The Future Buildings Standard

2. Consultation description

‘This is the second stage of our 2-part consultation on proposed changes to Part L (Conservation of fuel and power) and Part F (ventilation) of the Building Regulations.

Figure 3.1: Percentage carbon reduction by non-domestic building type for proposed Options 1 and 2.

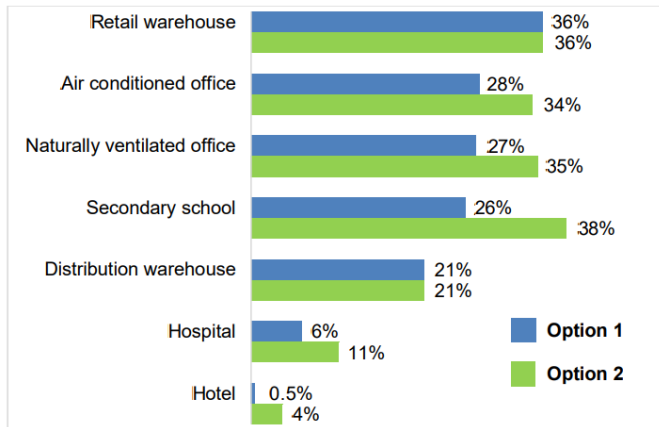
This is illustrated by Figure 3.1 from the Impact Assessment reproduced below which indicates that retail warehouses, offices and schools can achieve a reduction of 34-38 percent with the application of Option 2 proposals whereas this would be much lower in hotels and hospital 4-11 percent).

This difference between types of non-domestic buildings suggests that (energy) targets based on benchmarks for building types rather than a notional building approach would be a better placed to deliver ambitious change.

We would prefer an ‘energy hierarchy’ approach where the first step is to take all reasonable steps to reduce total anticipated energy demand for the building. This could be driven by both tighter minimum fabric requirements and absolute targets (kWh/m2/yr.) using accepted benchmarks where relevant.

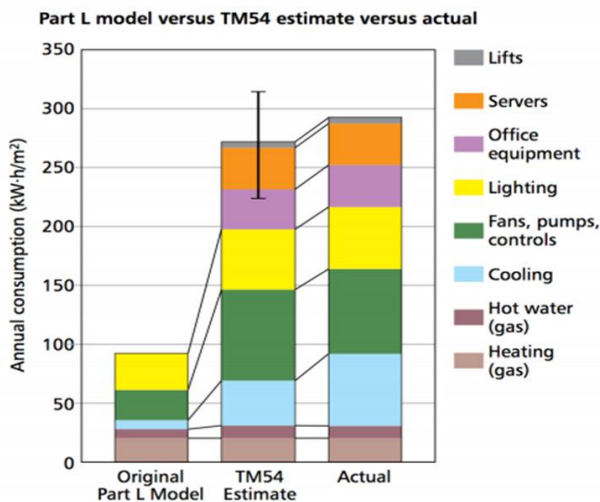
SBEM is used to calculate the target emissions rate (TER) and building emissions rate (BER) – modelled regulated energy usage and the CO2 emissions resulting from this.

In non-domestic buildings, the actual in-use energy usage and resulting emissions can be three times higher (as shown in the diagram from CIBSE below). The continued use of SBEM encourages a ‘design for compliance’ culture and makes it harder to predict operational energy performance.

We recommend that SBEM is replaced with a more sophisticated, advanced modelling methodology that can more accurately model operational energy building performance.
